ADDENDUM # 02

Project: Mt Diablo Unified School District
DENT Center
DENT Center Technology Infrastructure Upgrade

Date: August 1, 2025

TECHNOLOGY INFRA. FLOOR PLANS NEW - WINGS B, C, AND E - MDF 1.00

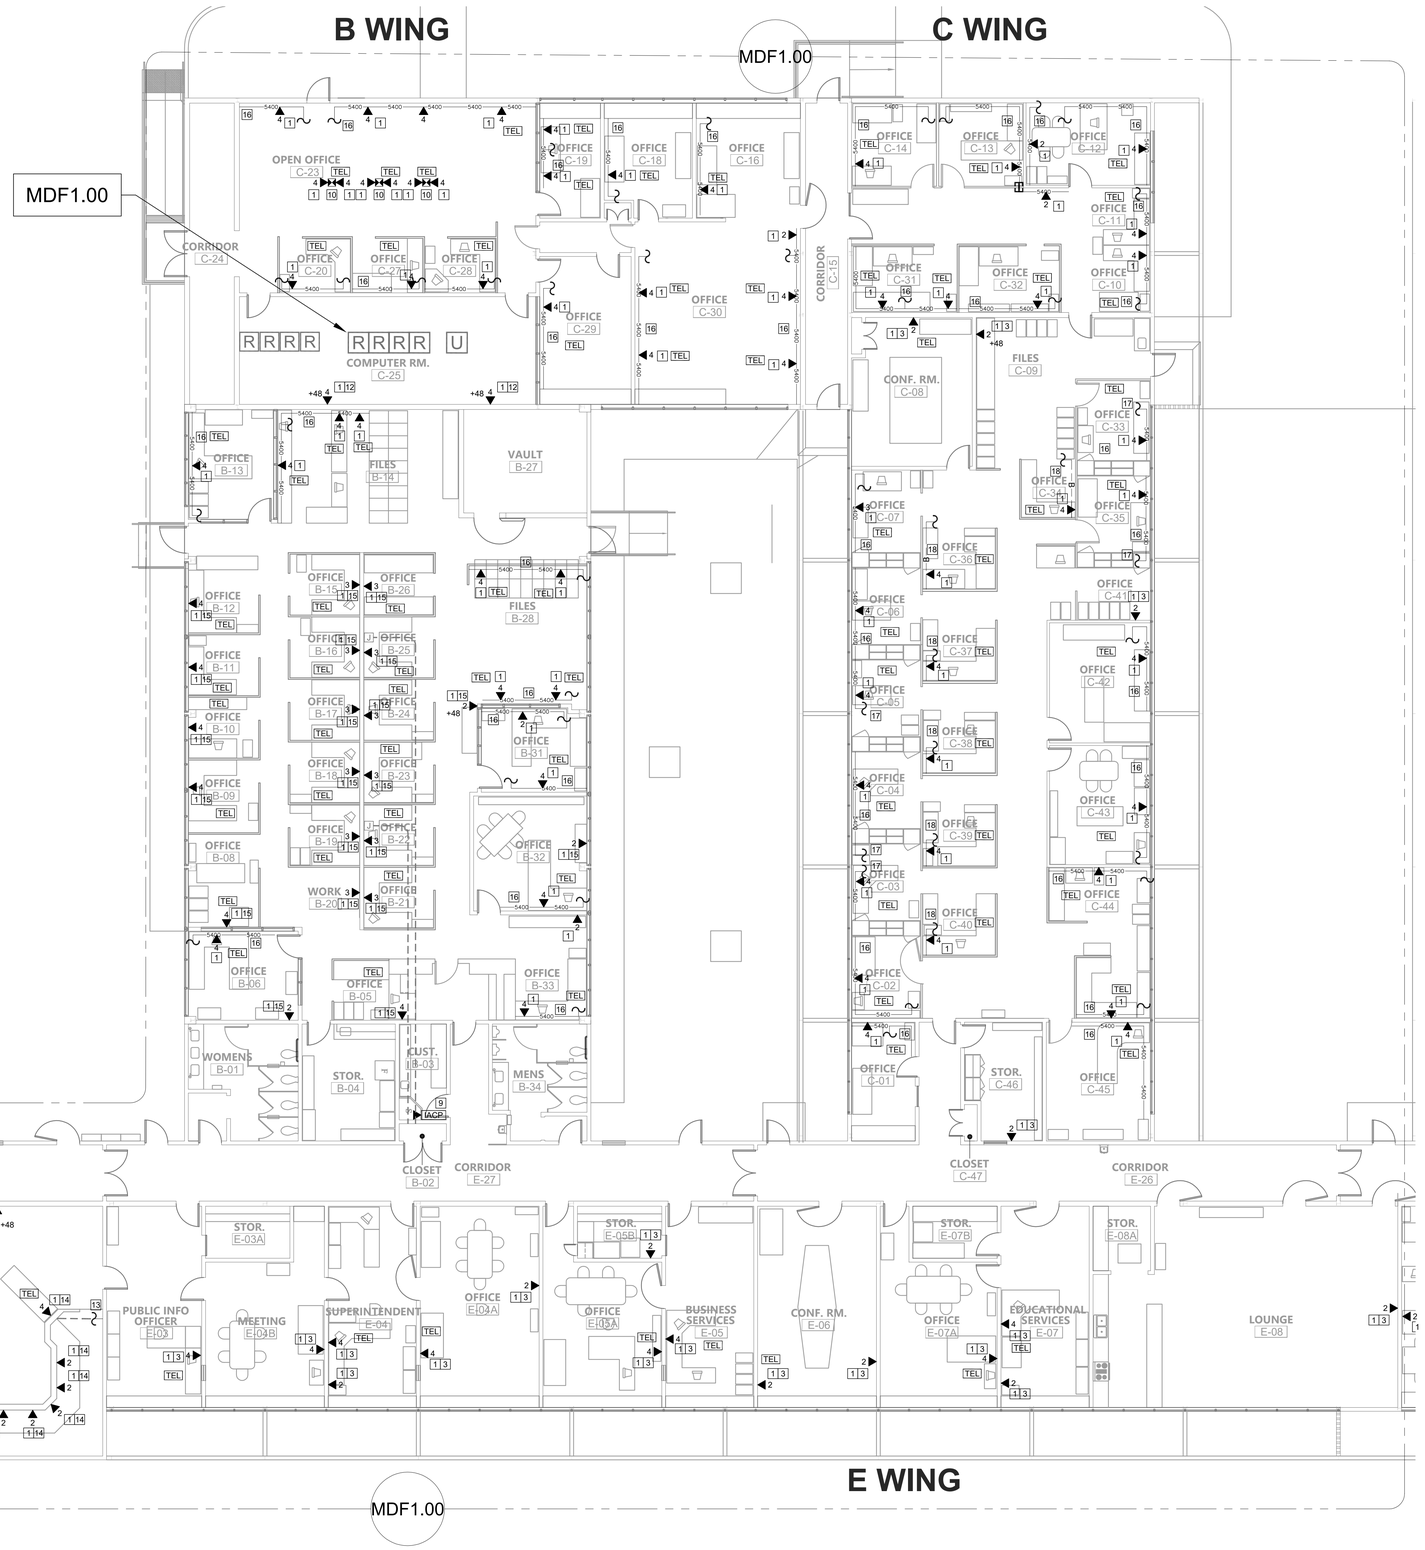
ITEM 1: T-200 Technology Infrastructure Floor Plans New – Wings B, C, and E – MDF 1.00

- Revisions to keynotes and add scope for temporary data at B-wing.

B-WING TEMPORARY DATA SCOPE:

1. MOST OF THE WORKSPACES IN THE B-WING ARE BEING RECABLED THROUGH EXISTING UNDERSLAB CONDUIT.
2. THE EXISTING ACTIVE DATA AND PHONE CABLING IN THES CONDUITS WILL NEED TO BE REMOVED IN ORDER TO PULL IN THE NEW CABLING.
3. TO ACCOMODATE THIS, TEMPORARY DATA AND PHONE CABLING WILL NEED TO BE FED FROM OVERHEAD FOR EACH WORKSPACE.
4. PRIOR TO DEMO, TONE EACH ANALOG PHONE CABLE FROM THE 66-BLOCK IN B-02 TO EACH WORKSPACE. PROVIDE A NEW TEMPORARY COPPER CABLE, FED OVERHEAD, FROM THE 66-BLOCK TO EACH WORKSPACE.
5. PROVIDE A CAT6A COPPER FEED FROM THE MDF TO OWNER-FURNISHED TEMPORARY SWITCHES TO RE-SERVE ALL ACTIVE DATA REQUIRED AT EACH WORKSPACE.
6. AFTER CUTOVER TO THE NEW SYSTEMS, DEMO ALL TEMPORARY CABLING.

TECHNOLOGY INFRA. FLOOR PLANS NEW - WING A - IDF 1.01

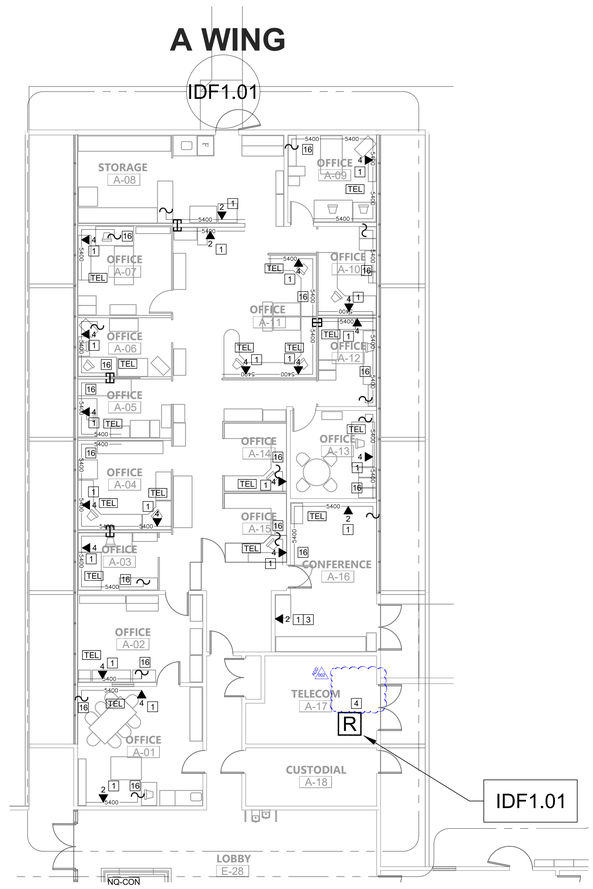
ITEM 2: T-202 Technology Infrastructure Floor Plans New – Wing A – IDF 1.01

- Revisions to keynotes and update keynote at IDF1.01 location.

3. PROVIDE CUT-IN BACKBOX AND FISH TO ACCESSIBLE CEILING. Addendum 2
4. NEW IDF EQUIPMENT WILL BE CO-LOCATED IN AN EXISTING TELECOM RACK AT THIS LOCATION.

14. ROUTE VIA (E) CHASE IN CASEWORK.
15. ROUTE VIA (E) UNDERSLAB CONDUIT PATHWAY TO CLOSET B-02. Addendum 2
16. PROVIDE (N) WM5400 SURFACE RACEWAY TO REPLACE (E) PN20 SURFACE RACEWAY. REWORK (E) ELECTRICAL INTO (N) RACEWAY. PROVIDE ALL (N) DEVICES, LIKE FOR LIKE WITH EXISTING. DEMO ABANDONED PN20. FABRICATE CUSTOM FURRING STRIPS TO ACCOMODATE FOR UNEVEN WALL CONDITIONS AS REQ'D, TYP. OF EXISTING.

TECHNOLOGY INFRA. FLOOR PLANS NEW - WINGS D AND E - IDF 1.02 AND 1.03

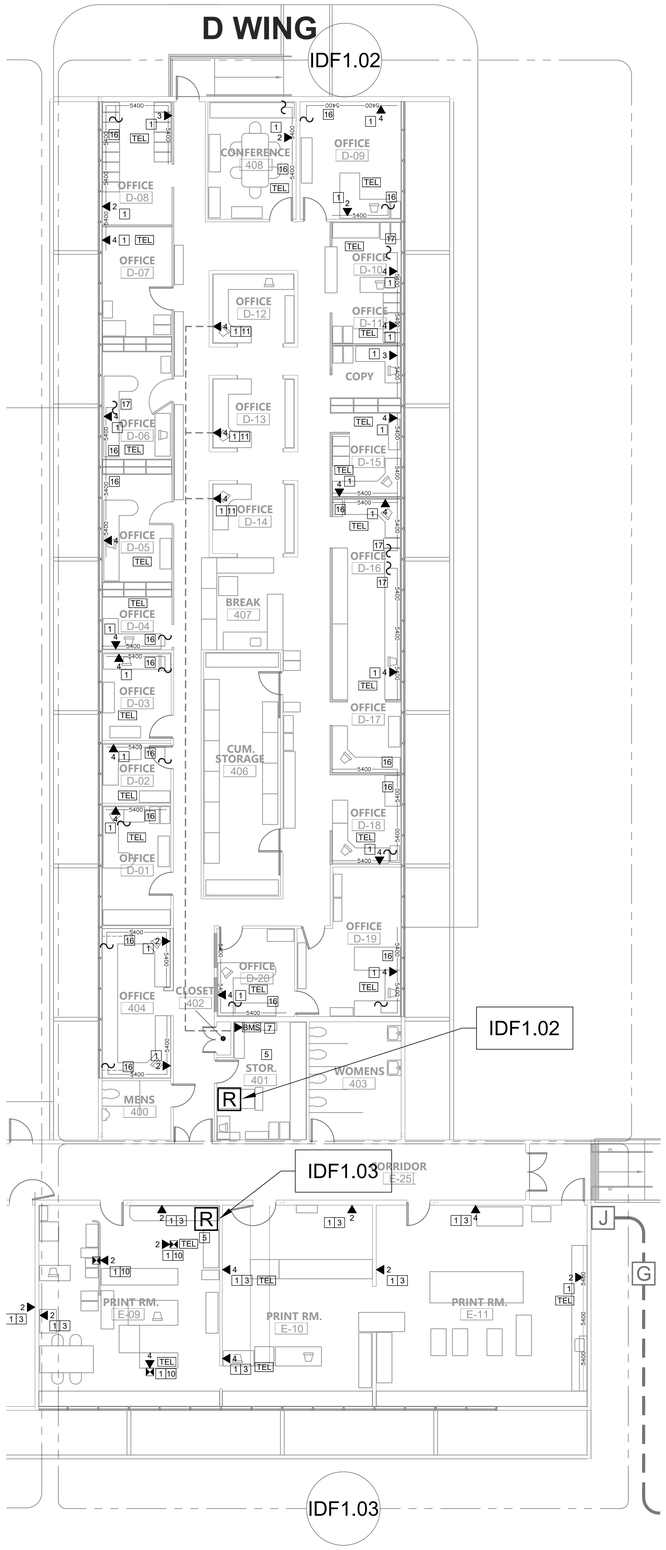
ITEM 3: T-204 Technology Infrastructure Floor Plans New – Wings D and E – IDF 1.02 and 1.03

- Revisions to keynotes.

TECHNOLOGY INFRA. FLOOR PLANS NEW - ANNEX - IDF 1.04 AND 1.05

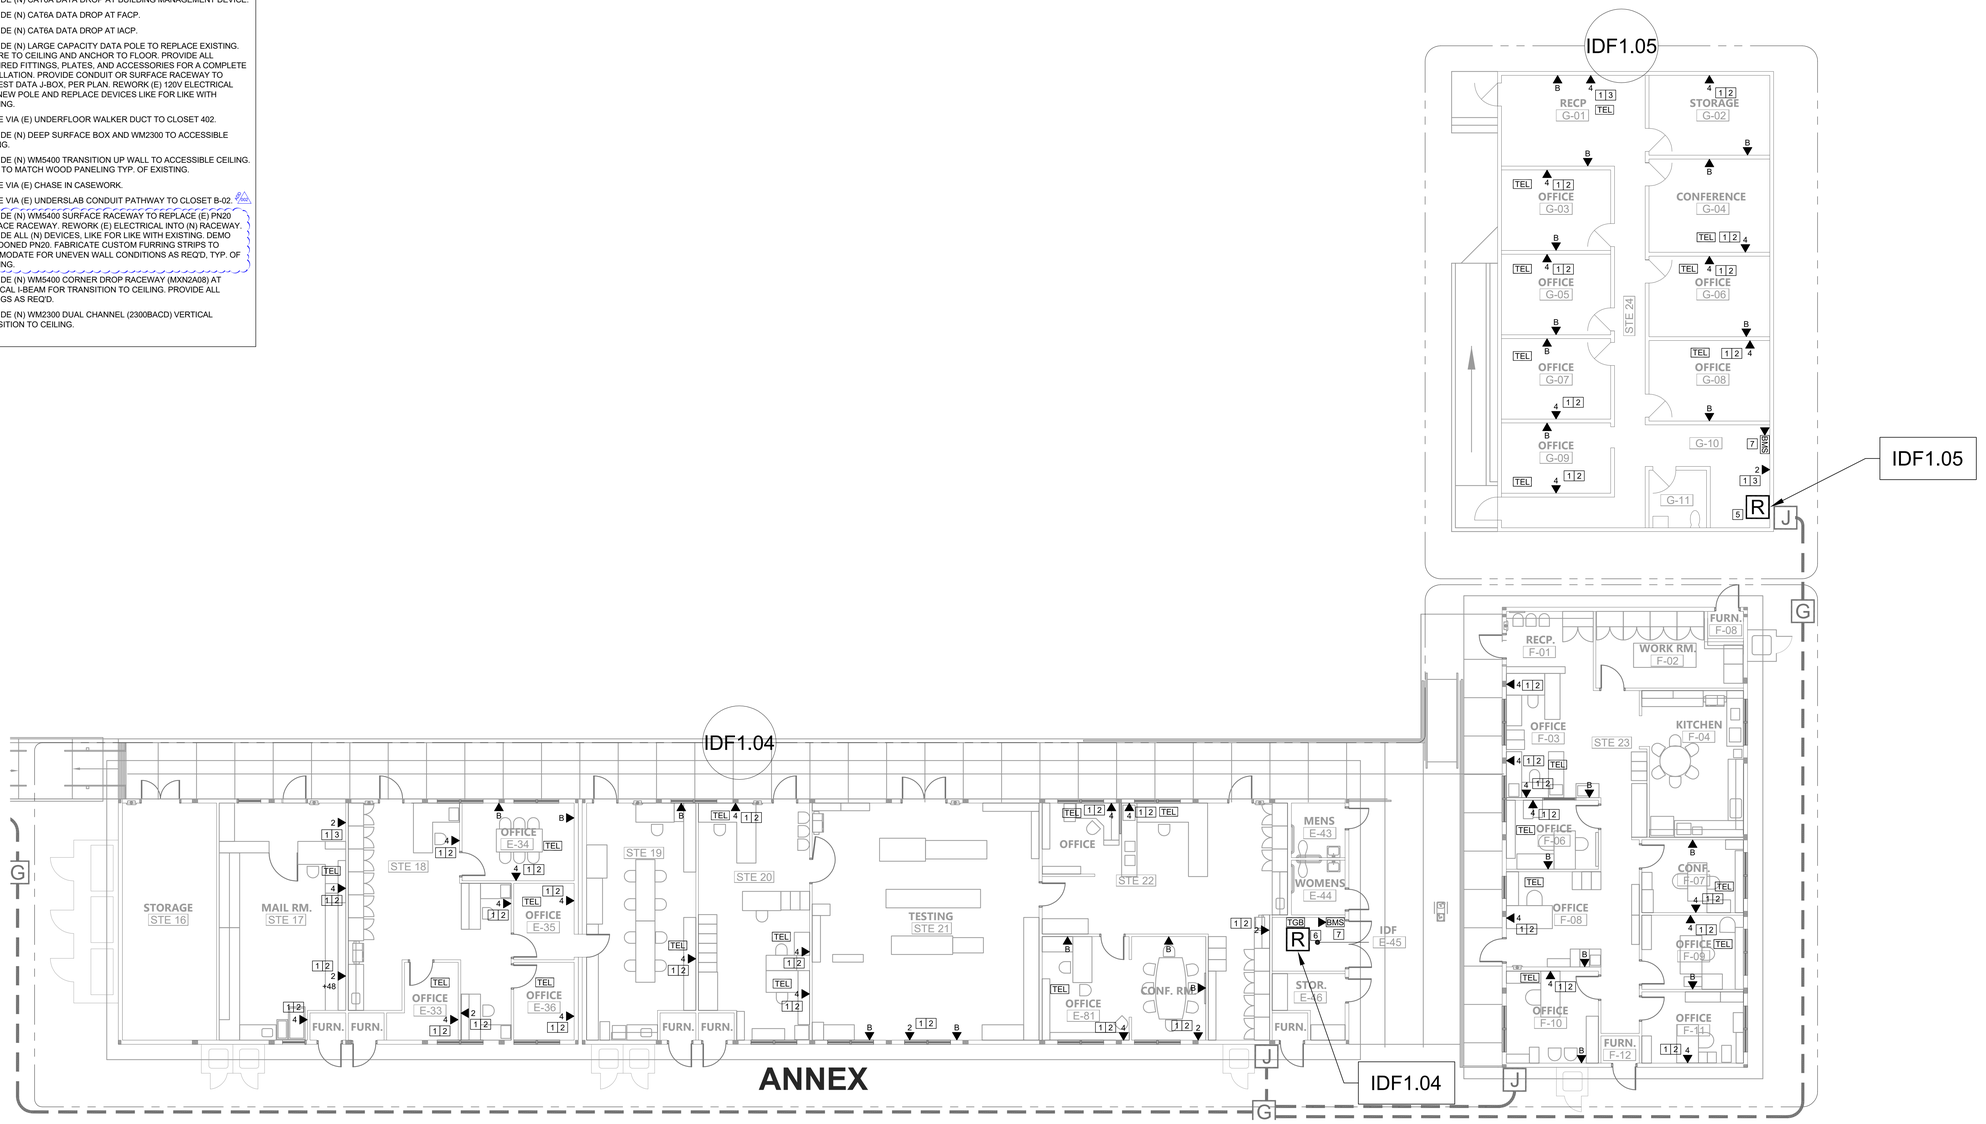
ITEM 4: T-206 Technology Infrastructure Floor Plans New – Annex – IDF 1.04 and 1.05

- Revisions to keynotes.

TECHNOLOGY INFRASTRUCTURE SINGLE LINES

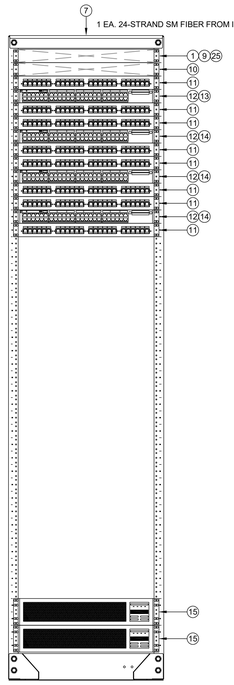
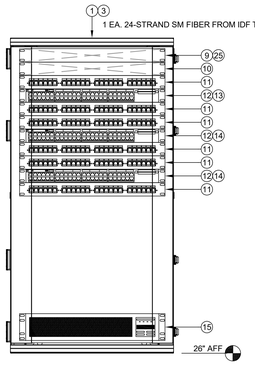
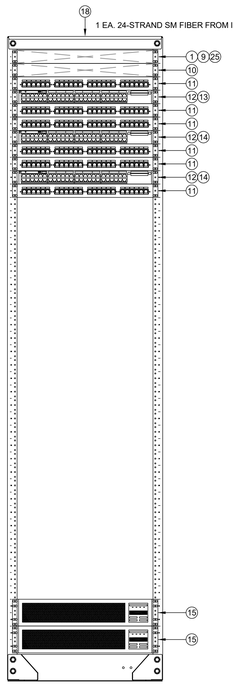
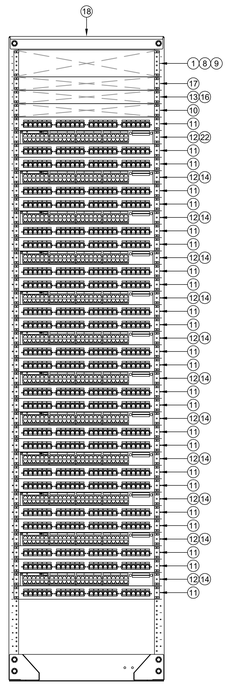
ITEM 5: T-700 Technology Infrastructure Single Lines

- Revisions to equipment schedules.

3 FIBER LIU DETAIL W/ FIBER OPTIC CABLE LABELING (ABV./BELOW GROUND)
SCALE: NONE

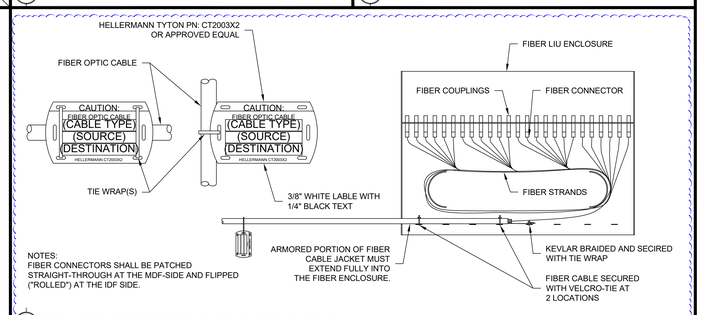
ITEM 6: T-801 Technology Infrastructure Details

- Updated fiber termination detail.

NOTES:
FIBER CONNECTORS SHALL BE PATCHED STRAIGHT-THROUGH AT THE MDF-SIDE AND FLIPPED ("ROLLED") AT THE IDF SIDE.

7 PATCH PANEL CONNECTION DETAIL - 2RU
SCALE: NONE

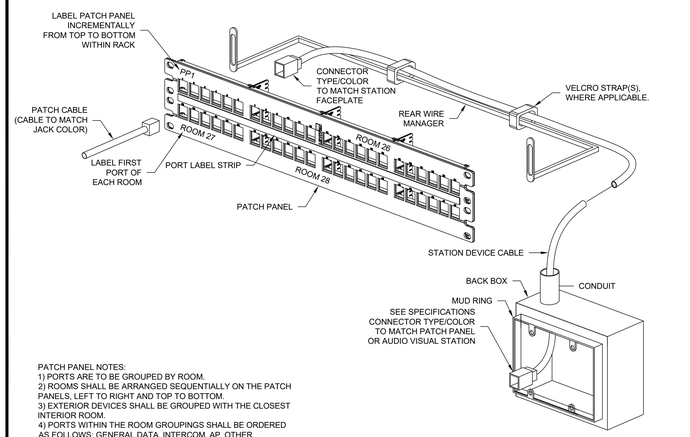
Question #3: Does the different system cabling need to be separated on their own, distinguished patch panels? For example, do WAP's need their own patch panel as well as clocks / speakers and cameras?

Answer #3: No. Refer to Detail 7/T-801 for patch panel/port arrangements.

PATCH PANEL NOTES:
1) PORTS ARE TO BE GROUPED BY ROOM.
2) ROOMS SHALL BE ARRANGED SEQUENTIALLY ON THE PATCH PANELS, LEFT TO RIGHT AND TOP TO BOTTOM.
3) EXTERIOR DEVICES SHALL BE GROUPED WITH THE CLOSEST INTERIOR ROOM.
4) PORTS WITHIN THE ROOM GROUPINGS SHALL BE ORDERED AS FOLLOWS: GENERAL DATA, INTERCOM, AP, OTHER.
5) DO NOT SEGREGATE PATCH PANELS BY DEVICE TYPE UNLESS SPECIFICALLY DIRECTED ON THE IDF ELEVATION.
